Mechanical Issues on the QBB Design: Suzuki July 17th (updated with replies to Jim Fast's questions)

Summary of B2GM12-BPID: Suzuki Mechanics, July 23rd.

Mechanical Issues and CRT Progress: Suzuki July 29th.

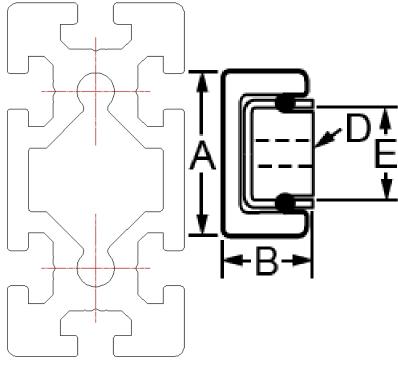
Possible slide mounting: switch from $100 \times 100 \text{mm}$ extrusion to $100 \times 50 \text{mm}$ on short horizontal bars, to allow for width of slide rail (no scale in this slide).
